Z-7
(2013)

EXHIBIT A

AREA = 0.4389 ACRES
3101 RUSTELL ROAD

PETITION NO: Z-7

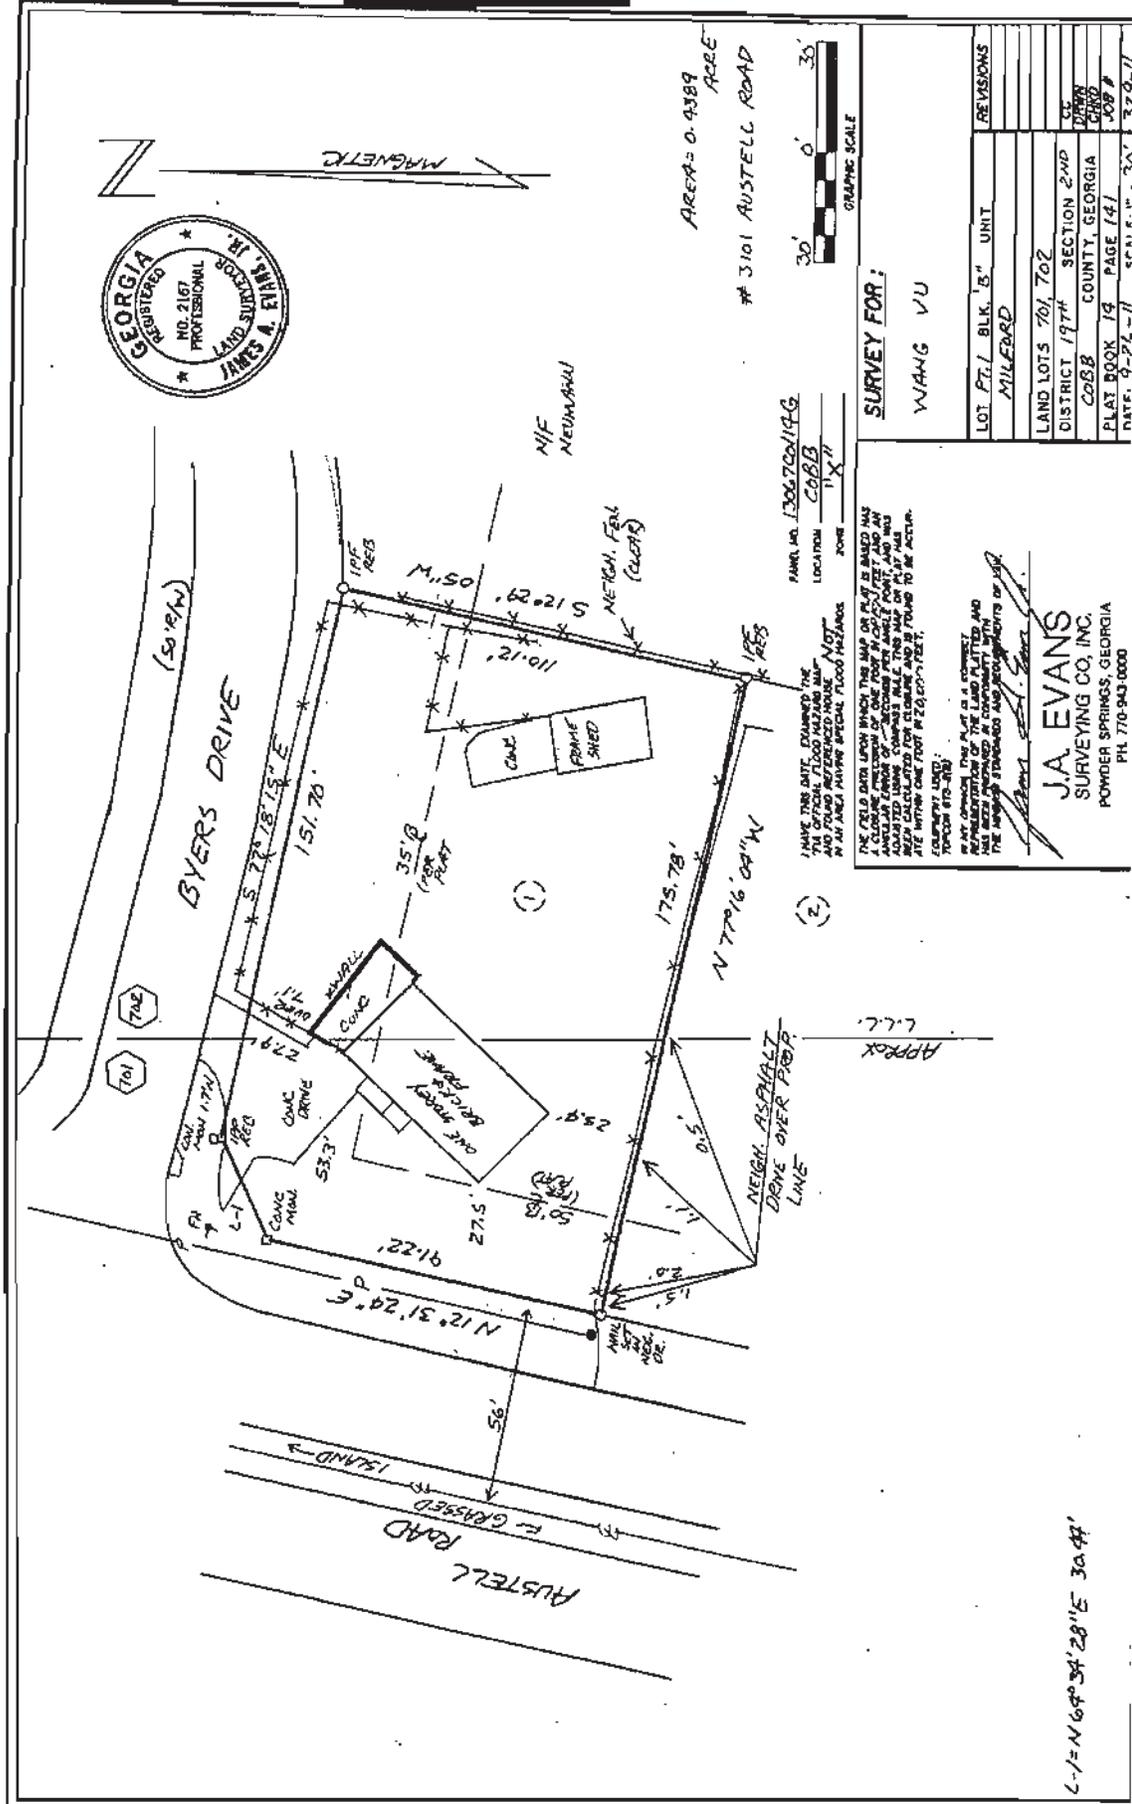
- No Stormwater controls shown.
- Copy of survey is not current – Additional comments may be forthcoming when current site conditions are exposed.
- No site improvements showing on exhibit.

Recommend relocating and reconstructing the driveway to meet the commercial standard.

Recommend interparcel access with 3113 Austell Road.
